**FIVE-YEAR ENVIRONMENTAL AUDIT  
FORT KNOX MINE, TRUE NORTH MINE AND TWIN CREEK ROAD**

*Fairbanks Gold Mining, Inc.  
State of Alaska, Department of Natural Resources  
State of Alaska, Department of Environmental Conservation*

*Golder Associates Inc.  
1750 Abbot Rd., Suite 200  
Anchorage, Alaska 99507*

March 1, 2004

**Figure 19**

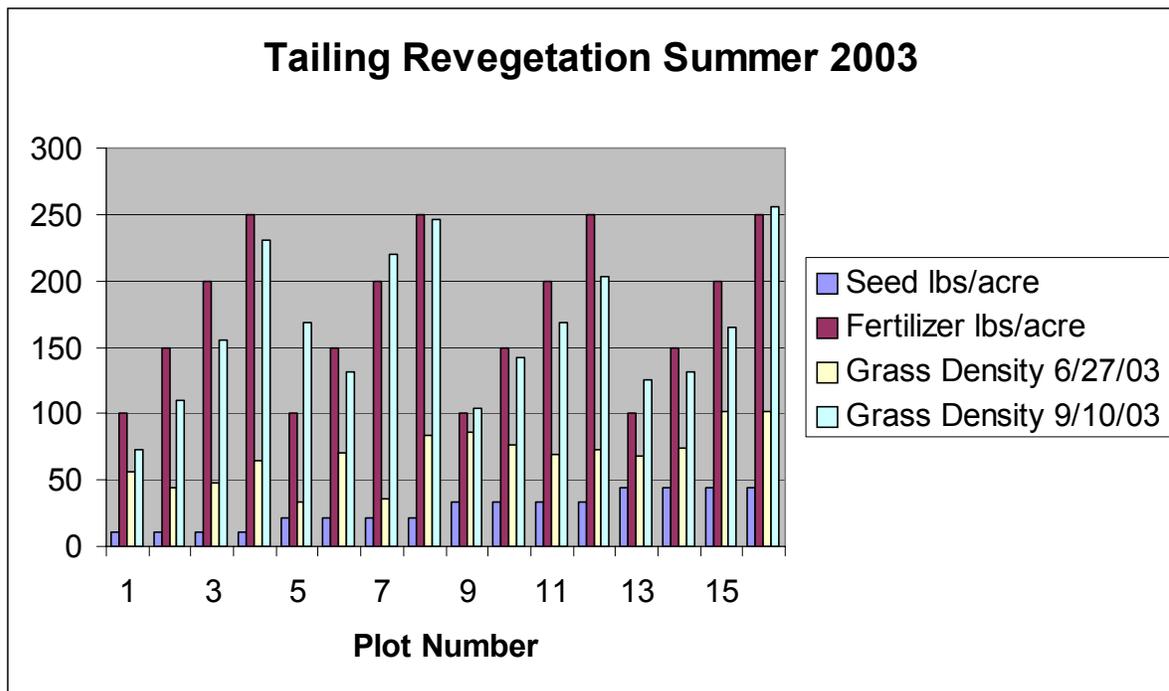
FGMI has implemented a test plot study in the summer of 2002 to evaluate the effectiveness of direct revegetation of tailings without the addition of organic matter. The test plots were constructed on the

Barnes Creek waste rock dump by placing a layer of tailings over approximately 2,800 square feet. 16 test plots are in progress with differing seed and fertilizer application rates. FGMI is documenting revegetation success using the Transect Intercept Method. The test plot seed mix was provided by the Alaska Plant Materials Center. Our review of the test plots indicated that revegetation success was related directly to fertilizer and seed addition rates as shown on Figure 19. Photographs of the test plots are included in Appendix E. These results are short-term (one season) and long-term success (3 to 5 years) must be demonstrated to justify this approach. Furthermore, it is our understanding that FGMI will be contacting the Alaska Plant Materials Center to follow up on their original recommendations and for study review.

TITLE				<b>Tailings Water Quality - Nitrate</b>	
				Quarterly Monitoring Results	
DRAWN	CR	DATE	March 2004	JOB NO.	033-5601
CHECKED	RV	SCALE	na	DWG. NO.	
REVIEWED	RV	FILE NO.	Fort Knox Water Quality.xls	FIGURE NO.	<b>13</b>

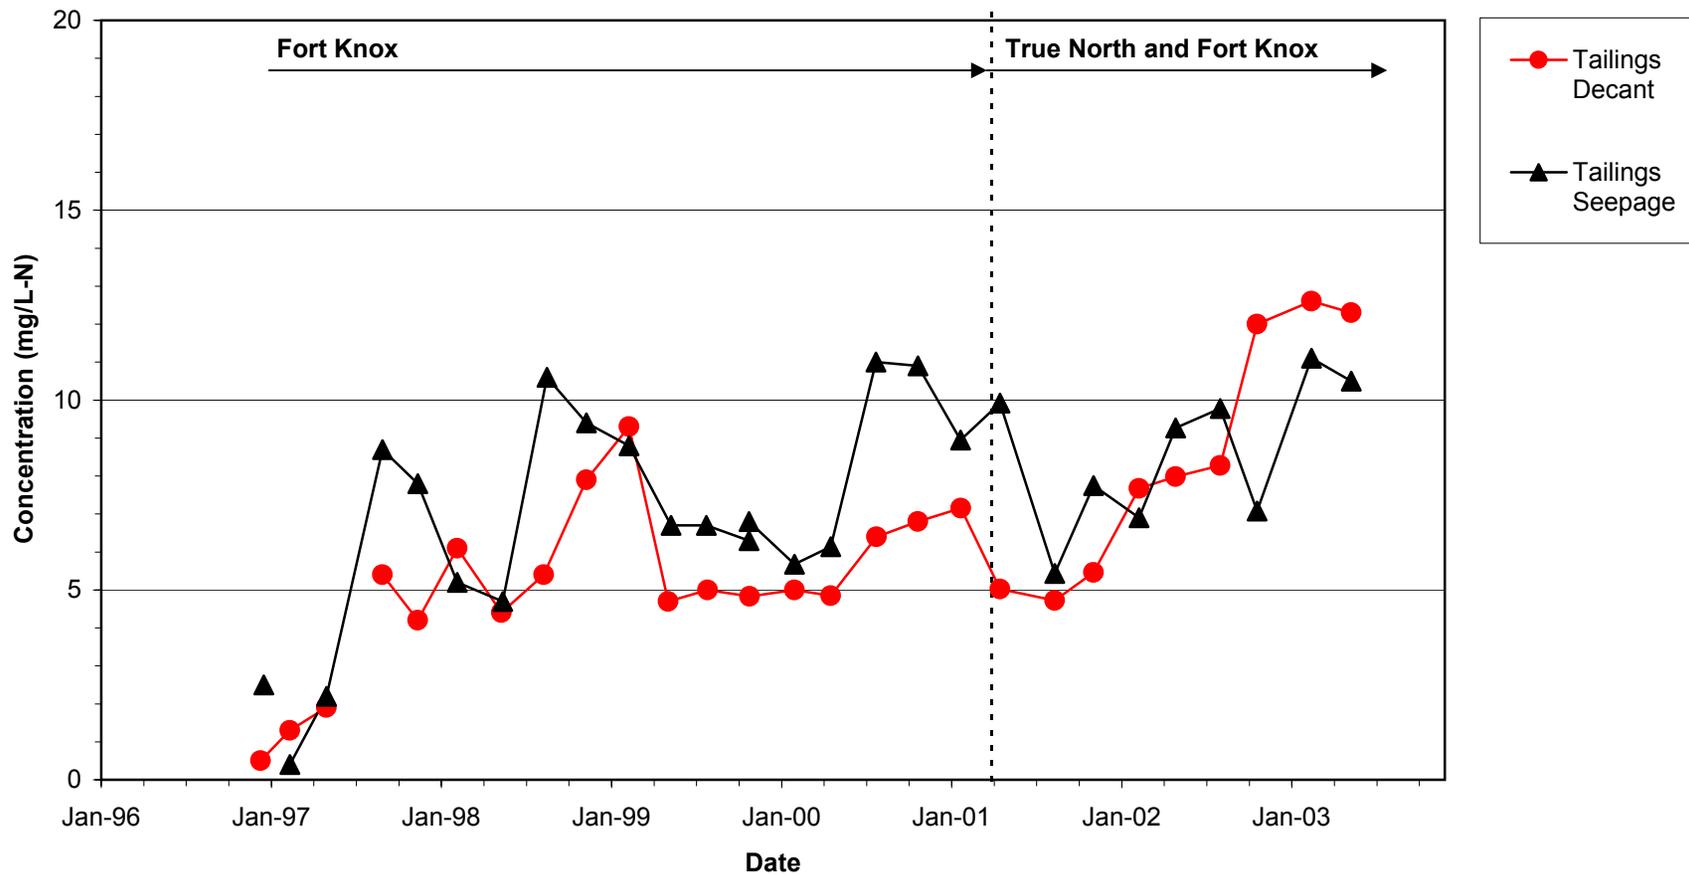
The tailings decant concentration plot shows a change in slope, indicative of a decline in the rate of concentration increase, in August 2001. A change in slope for the tailings seepage is observed in May 2002, 9 months following the observed change in tailings decant. Tailings pond water copper concentrations have increased as well, reflecting an increase in copper sulfate use. The gradual rise in tailings decant nitrate concentrations has continued over the life of the operation. Completion of a nitrogen balance of the cyanide and other nitrogen compounds may provide insight on the increasing nitrate trends.

The addition of lead nitrate in tailings processing is intended to remove sulfur from solution through the precipitation of a lead sulfate, thereby preventing the formation of thiocyanate (SCN). The use of lead nitrate in tailings processing since April 2001 has not resulted in significant increases in tailings decant lead concentrations. The increase in peak nitrate levels in 2003 relative to previous years is likely only in part attributable to the use of lead nitrate. Higher cyanide use would also contribute to higher tailings decant nitrate concentrations through natural decay of cyanide.

DRAWN	CR	DATE	March 2004	JOB NO.	033-5601
CHECKED	RV	SCALE	na	DWG. NO.	
REVIEWED	RV	FILE NO.	Fort Knox Water Quality.xls	FIGURE NO.	<b>15</b>

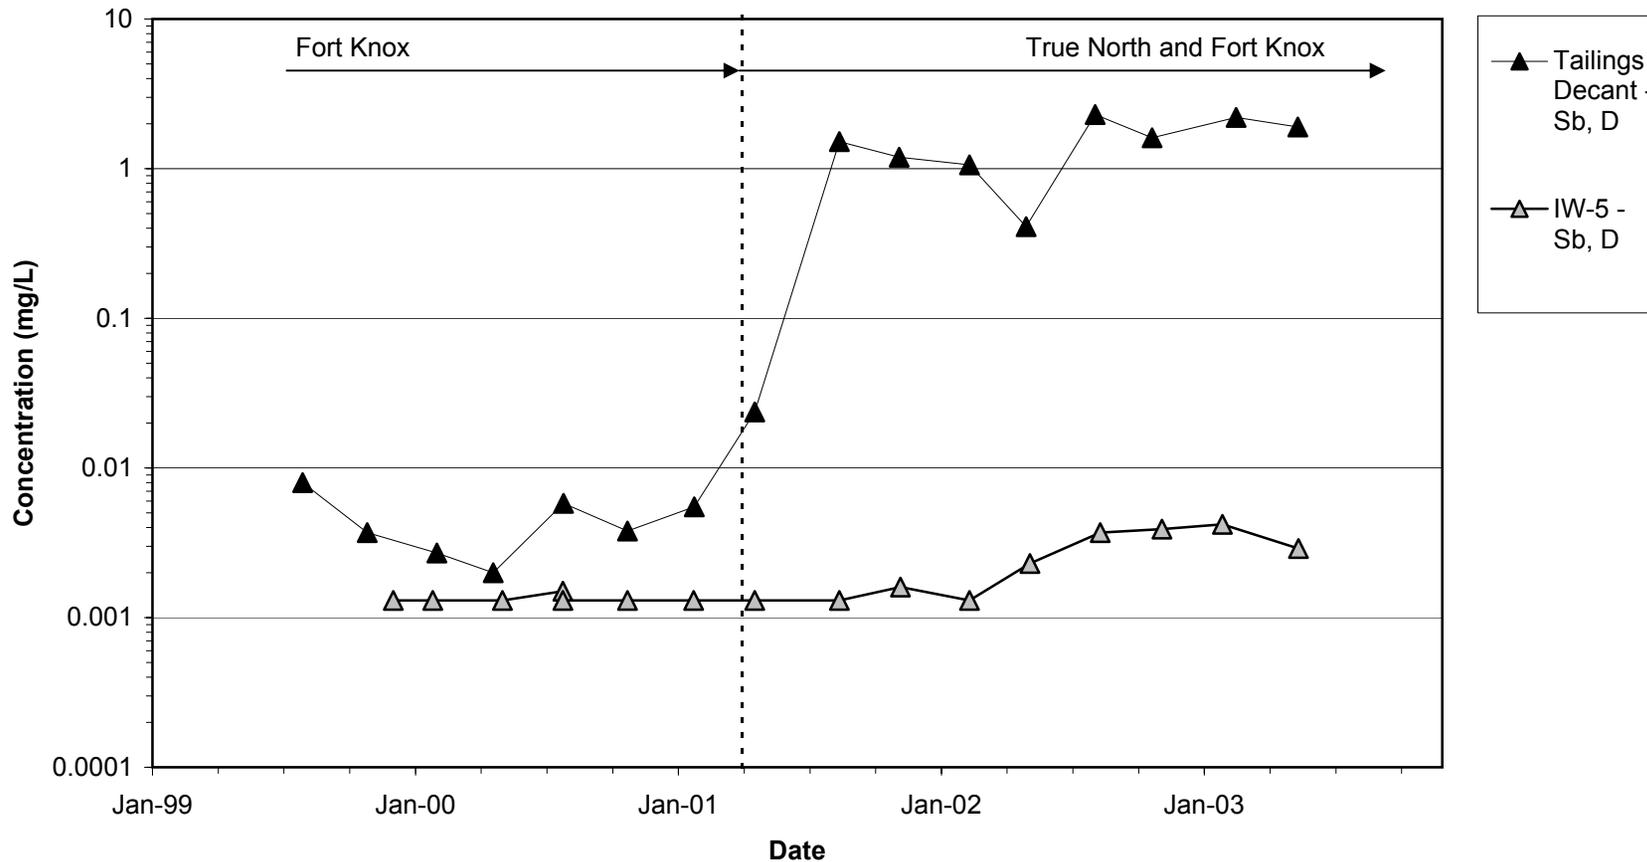
The addition of True North ore has resulted in an increase in tailings decant antimony concentrations. An increase in antimony concentrations has also been observed in tailings seepage indicating that antimony is mobile. Antimony has generally remained below detectable limits in downgradient monitoring and interceptor wells. A slight increase in antimony was observed at IW-5 in May 2002 (Figure 15).

DRAWN	<b>JSW</b>	DATE	<b>March 2004</b>	JOB NO.	<b>033-5601</b>
CHECKED	<b>PSM</b>	SCALE	<b>AS SHOWN</b>	DWG. NO.	
REVIEWED	<b>SHM</b>	FILE NO.		FIGURE NO.	<b>Figure 16</b>

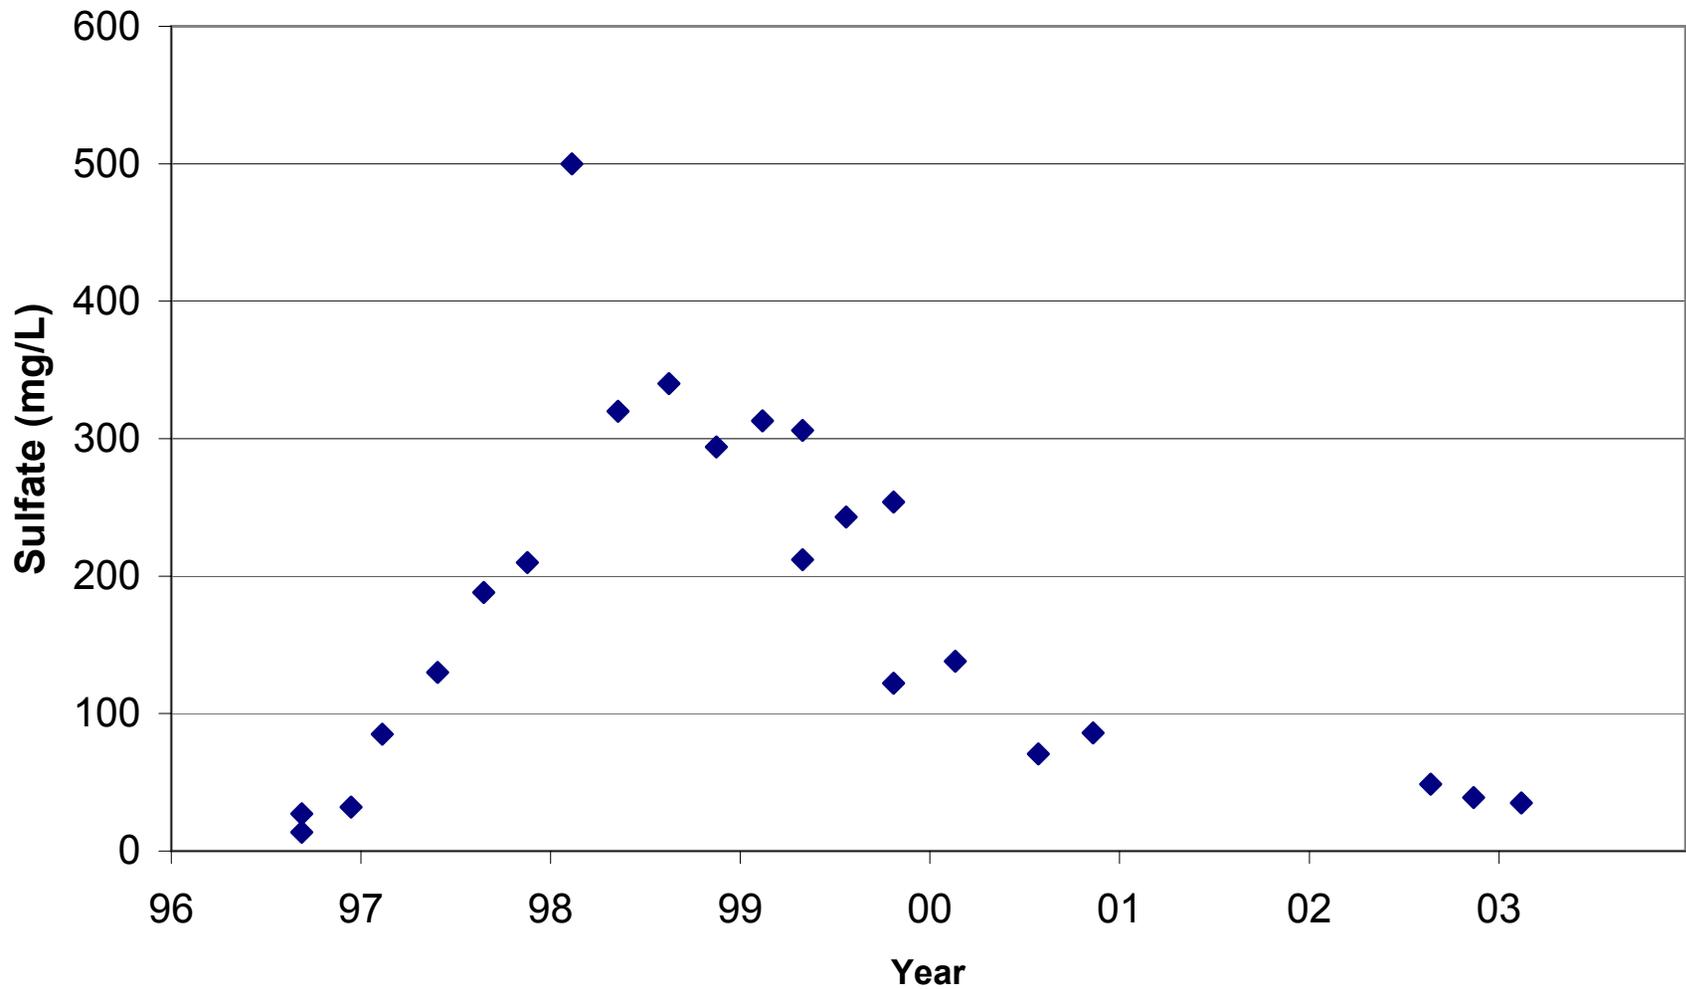
Water quality data from interceptor wells IW-1, IW-2, and IW-3, tailings seepage, and monitoring wells MW-5, MW-6, and MW-7 were plotted on a Piper diagram and compared. Figure 16 indicates that there are three discrete water types. The tailings seepage is calcium sulfate rich, but bicarbonate and chloride poor. The monitoring wells (MW-5, 6, and 7) are bicarbonate rich, and sulfate chloride poor, indicative of background groundwater quality. Monitoring wells MW-5 and MW-6 are calcium bicarbonate type and monitoring well MW-7 is sodium bicarbonate type. The interceptor wells (IW-1, 2, and 3) are a mixture of the other two types of waters. This correlation is valid since all the wells are completed in bedrock material.

DRAWN	<b>JSW</b>	DATE	<b>March 2004</b>	JOB NO.	<b>033-5601</b>
CHECKED	<b>PSM</b>	SCALE	<b>AS SHOWN</b>	DWG. NO.	
REVIEWED	<b>SHM</b>	FILE NO.		FIGURE NO.	<b>Figure 17</b>

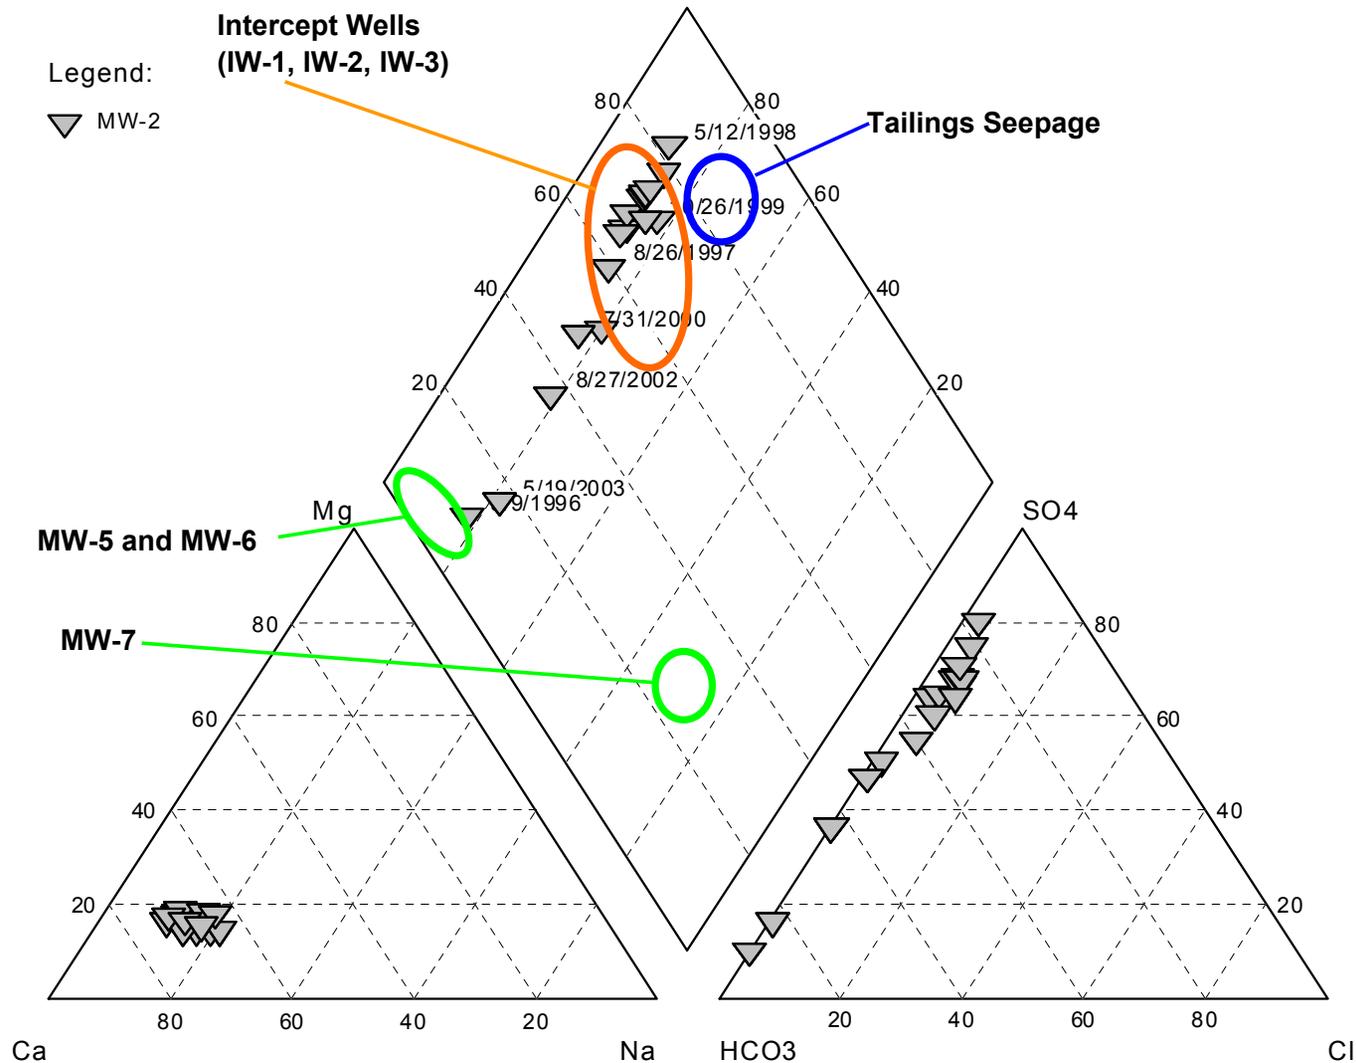
Since well MW-2 was the well that possibly detected tailing seepage, sulfate concentrations from that well were plotted over time (Figure 17). The plot clearly indicates background sulfate concentrations then peak sulfate concentrations in 1998 followed by a drop in sulfate concentrations back to background levels. Figure 18 is a Piper diagram of MW-2 water analyses over time. Water quality in 1996 is the same water type as background and current monitoring wells MW-5, 6, and 7 water type. MW-2 chemistry changes over time during 1997 and in 1998 it had a water type similar to tailings seepage. The water quality in MW-2 changed after the hydrogeological study was completed and additional interceptor wells were installed. The most recent water (5/19/2003) quality in MW-2 is almost identical to its original background concentrations from 1996 and the water type of the current monitoring wells (MW-5, 6 and 7).
